From: [REDACTED]
Cc: [REDACTED]
Subject: RE: TR010027: M42 Junction 6 Improvement - Applegreen plc Deadline 3 Submissions
Date: 15 July 2019 17:16:35
Attachments: [Applegreen DL3 submissions - final.pdf](#)
[Technical Note on Free Flow Junction Alternative for M42 J5a - final.pdf](#)
[Appendices A-E to Applegreens D3 Submissions.zip](#)

APPLEGREEN PLC

**M42 Junction 6
Development Consent Order Application**

Technical Note on Free Flow Junction Alternative for M42 J5a

Figure 1: Junction 5a Free Flow Alternative Layout

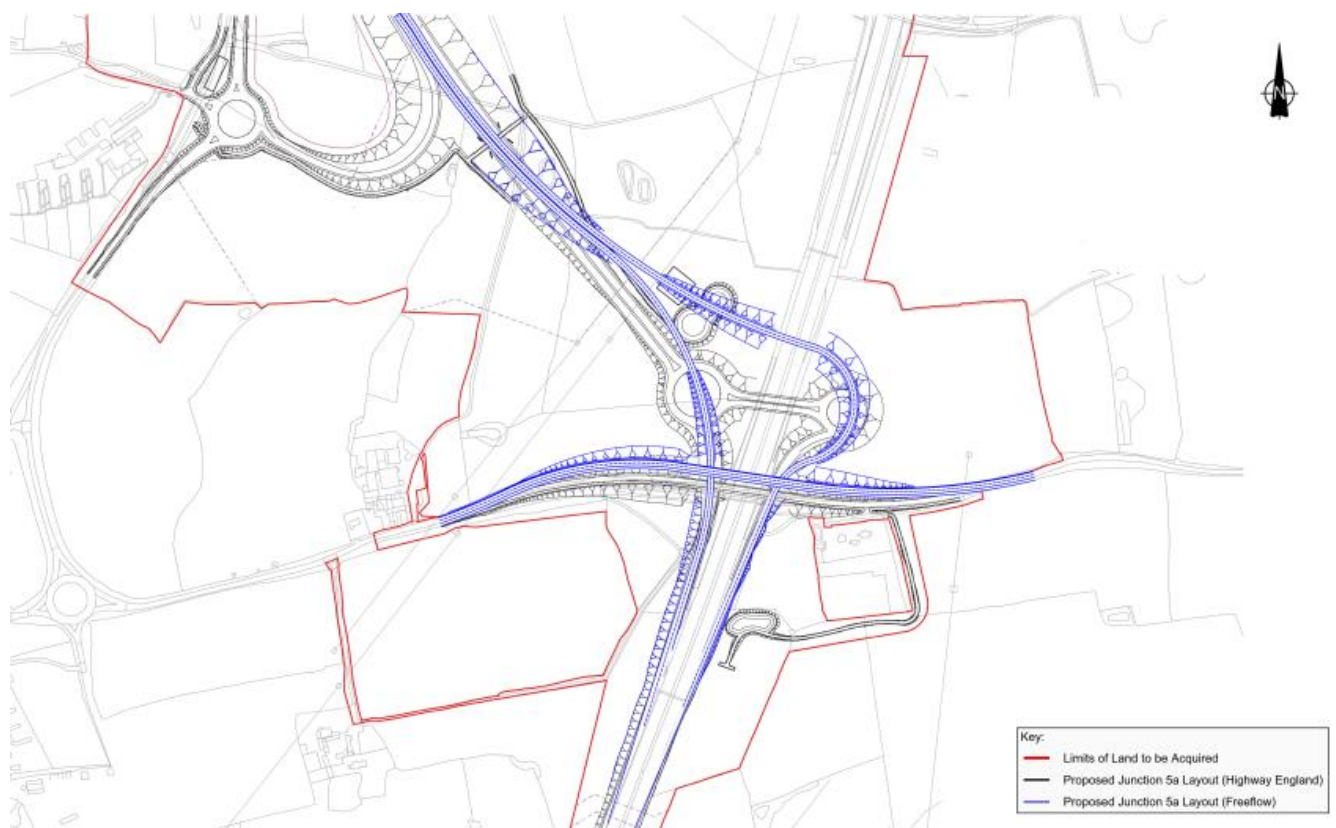
9. The road connecting the M42 northbound with the link to the A45 would follow the horizontal and vertical alignment of the DCO scheme up to the end of the diverge from the motorway. At this point the DCO scheme starts to climb up to get to the level of the western dumbbell roundabout. In the free flow alternative the connecting road would stay at the same level as the motorway mainline until it has passed under Solihull Road. This would have two impacts on Solihull Road. It would allow the new bridge to be lower and to be located further north.

10. Having passed under Solihull Road, the connecting road would climb up to existing ground level in a location close to where the DCO western roundabout would be. The road would then continue north west, tying in with the DCO alignment before the Catherine de Barnes junction. The road would remain at existing ground level as it passes under the overhead cables then drop down into cutting in a similar arrangement to the DCO scheme.

11. The road connecting the link from the A45 with the M42 southbound would start to deviate from the DCO scheme to the south east of the Catherine de Barnes junction. The road would rise up to existing ground level before passing under the overhead cables in the same way the DCO scheme would. The road would then climb up to cross the M42 68 metres north of the proposed DCO crossing of the motorway. The road would then turn right, dropping down to pass under Solihull Road at the same level as the existing motorway mainline. The merge with the motorway will be identical to that proposed by the DCO scheme.
12. All the works for the free flow alternative could be constructed within the existing DCO boundary.

21. It can be seen from Figure 1 of this note that the alignment of the link to the A45 would be identical with the free flow alternative as with the DCO scheme where they would pass Brickhill village so there would be no difference in the impact on Brickhill village.

22. It can be seen from Figure 1 of this note that the alignment of the link to the A45 would be identical with the free flow alternative as with the DCO scheme where they pass the Brickhill Meadows SSSI so there would be no difference in the impact on Brickhill Meadows SSSI.

Figure 2: Solihull Road Bridge DCO Scheme Clearances

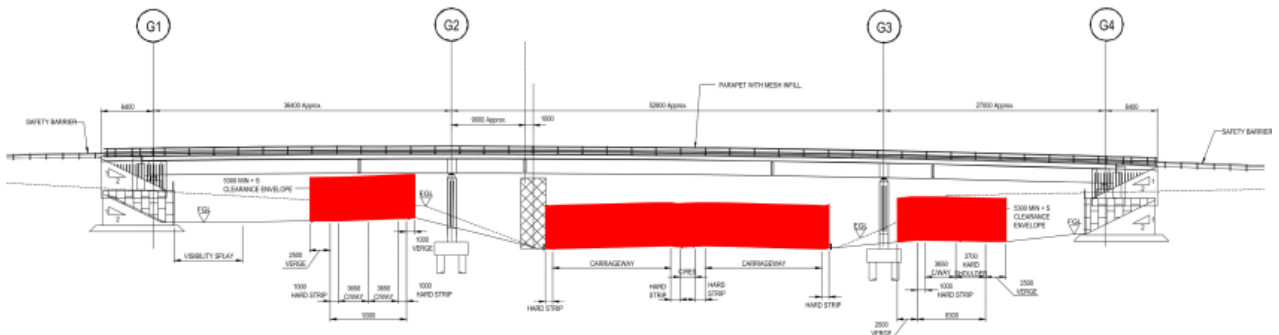
17. The design of the revised bridge and its alignment has the potential to have a significant impact on adjacent areas of ancient woodland. In the DCO proposal the height of the new bridge and the alignment of Solihull Road is constrained by the level of the proposed slip roads where they pass under Solihull Road. This is because the slip roads have to climb up from the level of the motorway mainline to connect to the roundabouts of the dumbbell junction which have to be set at a level that allows them to be connected by a bridge over the motorway.

18. The fact that the slip roads will be higher than the motorway mainline where they pass under Solihull Road means that the new bridge will have to be significantly higher than it would have to be just to cross the motorway. At the point where it would pass under Solihull Road, the northbound off-slip would be over 4 metres higher than the adjacent motorway. This is shown in Figure 2 of this note where the clearance envelopes for the mainline and the two slip roads are highlighted and it can be seen how much higher the envelope for the northbound off-slip is compared to the one for the motorway mainline. These rising slip roads also constrain the ability to align Solihull Road further north as the further north Solihull Road is located the higher it would need to be. The height and location of Solihull Road has an impact on the ancient woodland to the south.

Figure 3: Solihull Road Bridge Indicative Alternative with Free Flow Arrangement

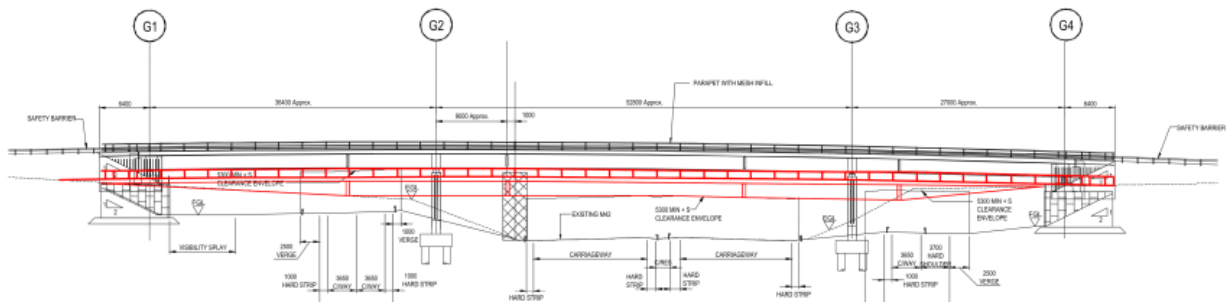
19. With the free flow alternative the proposed slip roads would be kept at the same level as the motorway mainline meaning that the clearance from the mainline would determine the height of the bridge. This also allows Solihull Road to be aligned further north without needing to be higher. The relative heights of the proposed DCO Solihull Road Bridge and what could be achieved with the free flow alternative are shown in Figure 3 of this note. As noted above, the height and location of Solihull Road has an impact on the ancient woodland to the south.

Figure 4: Relative Impact on Ancient Woodland

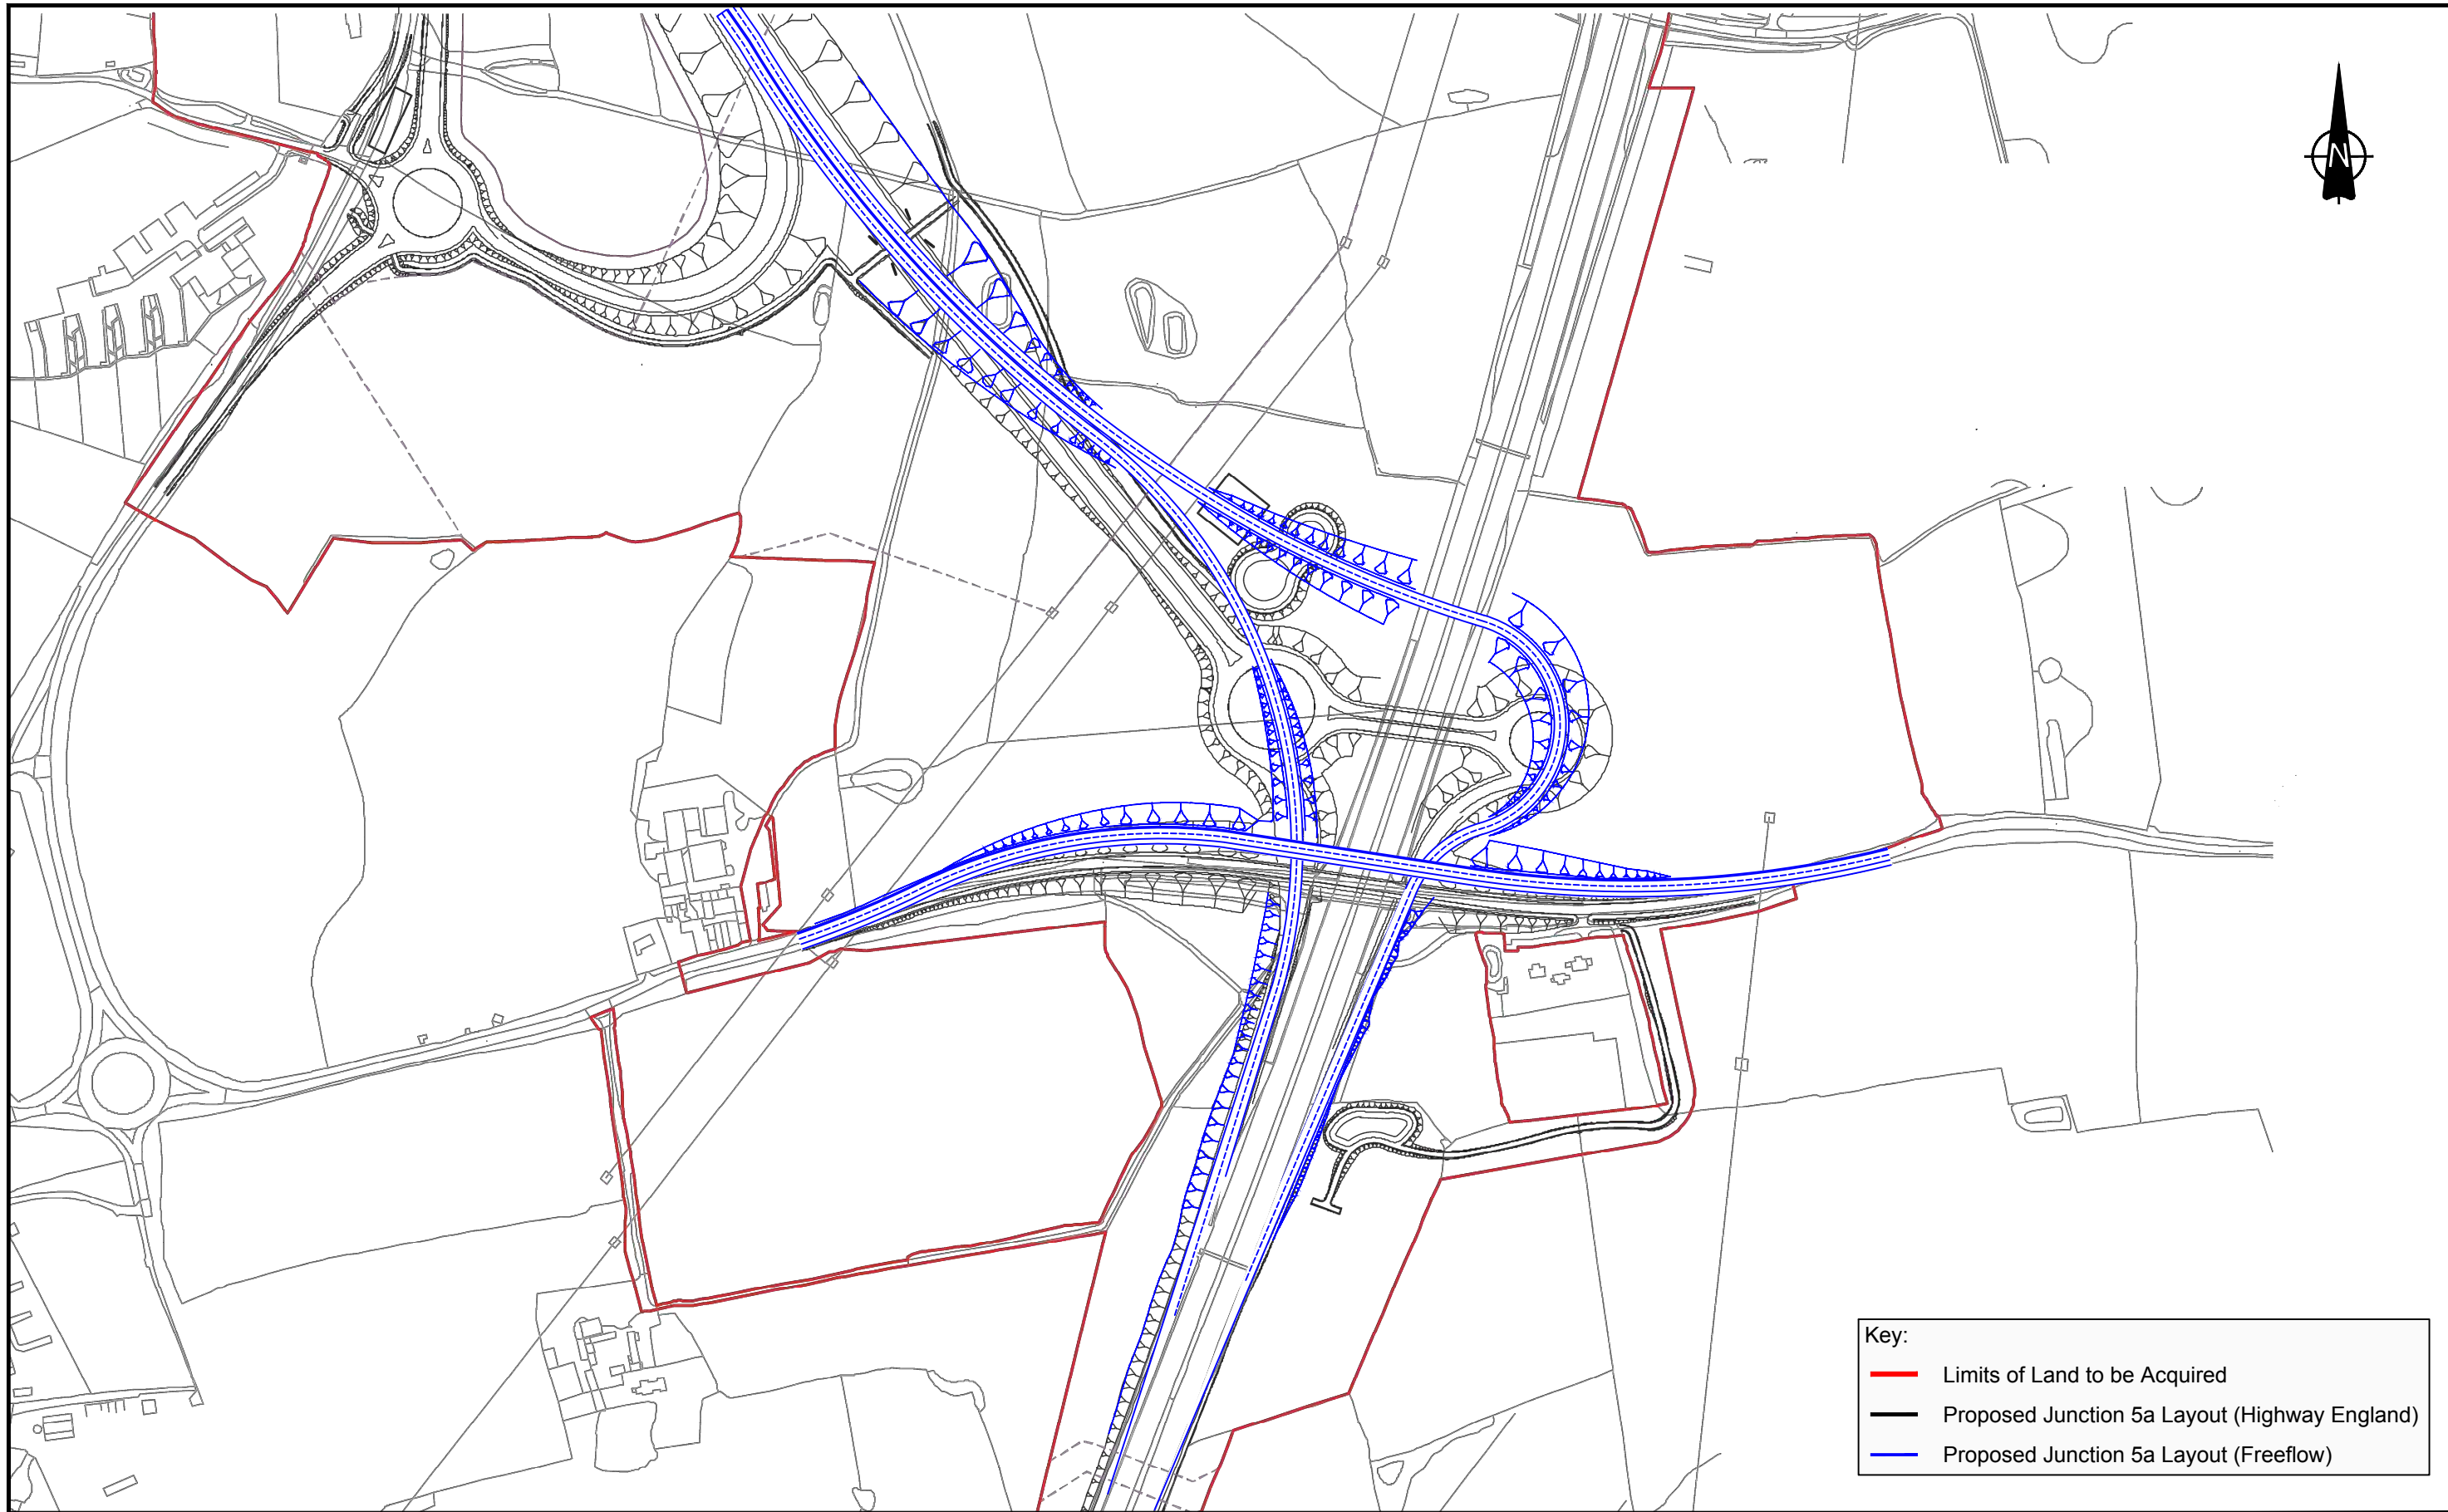
24. The DCO scheme has two impacts on the area of ancient woodland to the west of the M42 and the south of Solihull Road. The widening of the M42 corridor would impact on the eastern edge of the woodland. The extent of the encroachment would reduce as the off-slip heads north as the level of the slip road rises reducing the earthworks required. The significant height increase on Solihull Road would require earthworks that would encroach on the northern edge of the woodland.

25. The free flow option off-slip would have a similar encroachment on the ancient woodland at its southern end, but would have slightly more impact closer to Solihull Road as earthworks would be required to accommodate the level difference. The alignment and

level of Solihull Road that could be achieved with the free flow alternative would mean that no earthworks would be required to the south of the existing Solihull Road corridor and there would, therefore, be no impact on the northern edge of the ancient woodland.

26. The relative impacts of the two schemes are shown on Figure 4 of this note, which demonstrates that the overall net impact of the free flow option on these areas of ancient woodland, would be material less than the DCO junction 5a scheme.
